MODU CODE

Code for the construction and equipment of Mobile offshore drilling units, 2009

2010 Edition

Errata

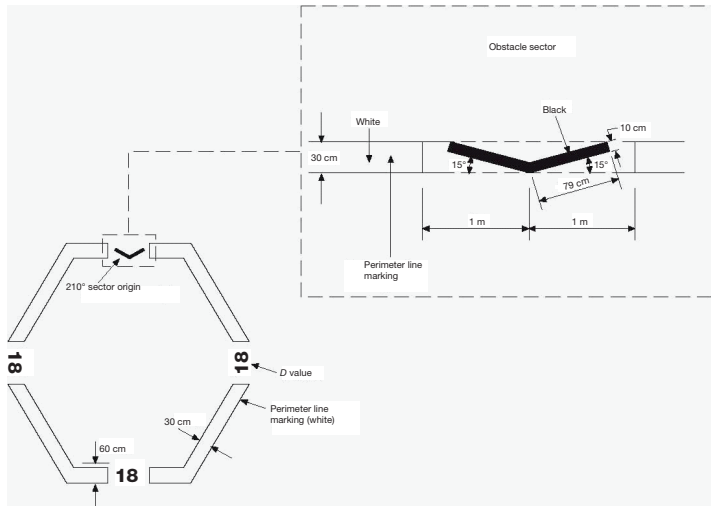
On page 168, replace the drawing “Figure 13-4 – Obstacle-free sector marking” with the figure below:
